DRAFT MOTION OF APPROVAL

FINAL SUBDIVISION APPROVAL

FOR: 539 AND 551 MANCHESTER RD
CROSBY II SUBDIVISION

CROSBY II SUBDIVISION

CUL-DE-SAC REMOVAL PLAN
CROSBY II SUBDIVISION
 PREPARED FOR
REJEAN JACQUES
 GLASTONBURY, CONN

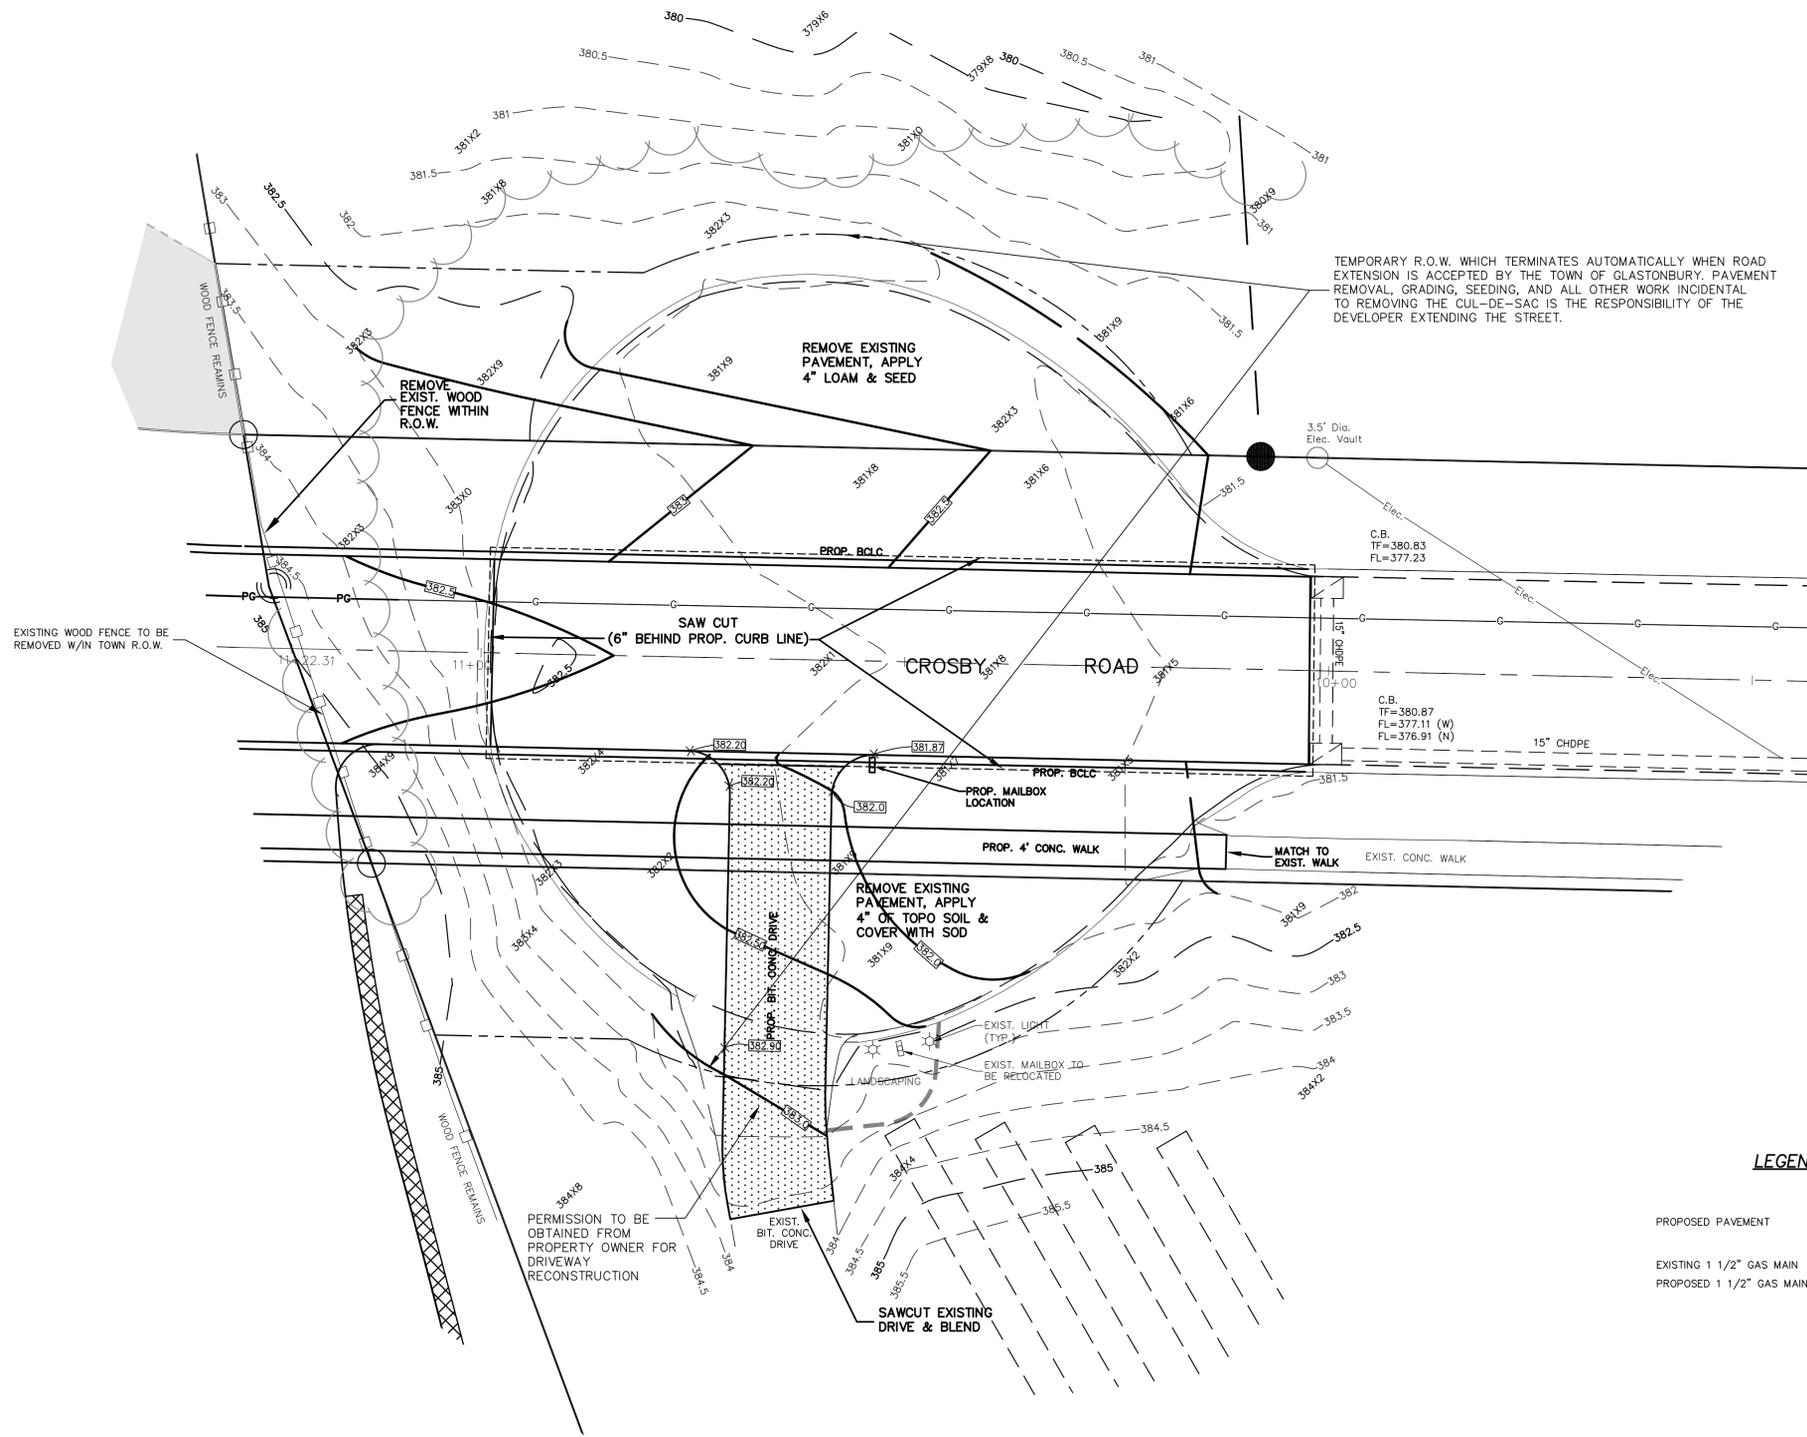
7. Provide additional proposed spot grades to clarify grading on sheet 5 of 11 for the existing driveway serving 470 Crosby Road to be extended as part of the project.

STORMWATER POLLUTION CONTROL PLAN
CROSBY II SUBDIVISION
PREPARED FOR
REJEAN JACQUES
GLASTONBURY, CONN

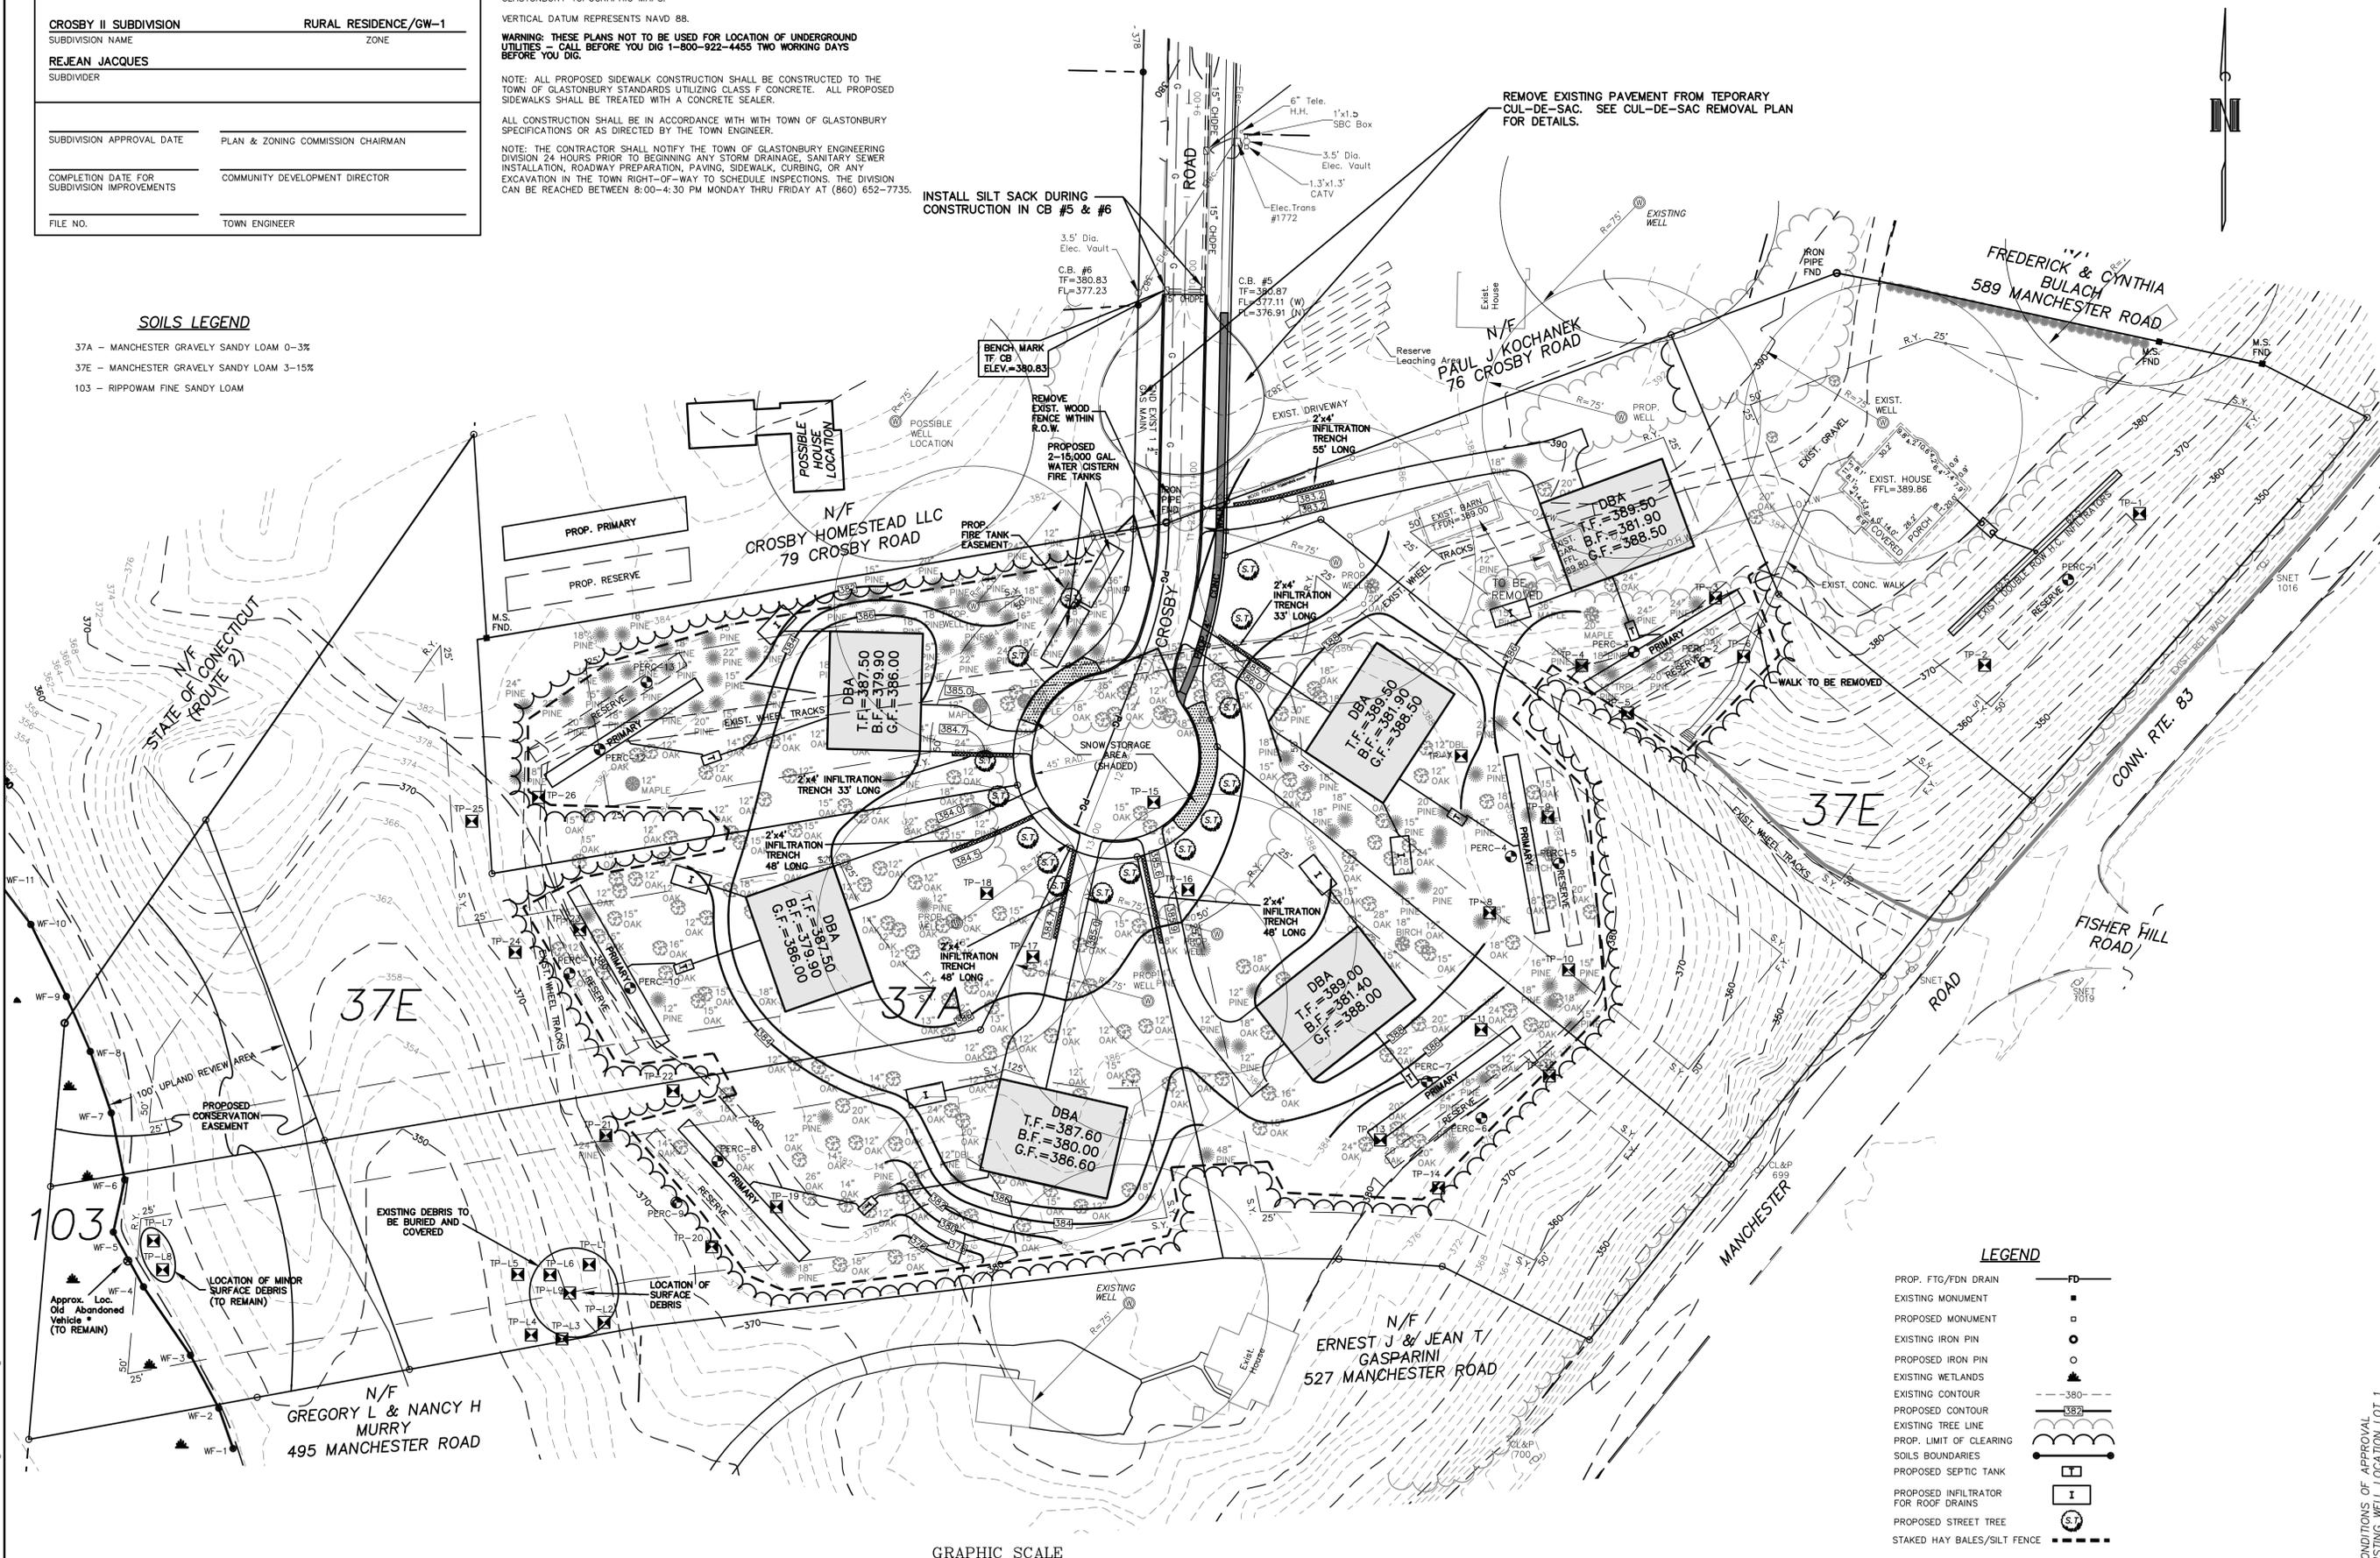
5. A narrative for maintenance of the proposed driveway infiltration trenches should be added to the stormwater maintenance narrative on sheet 3 of 11.
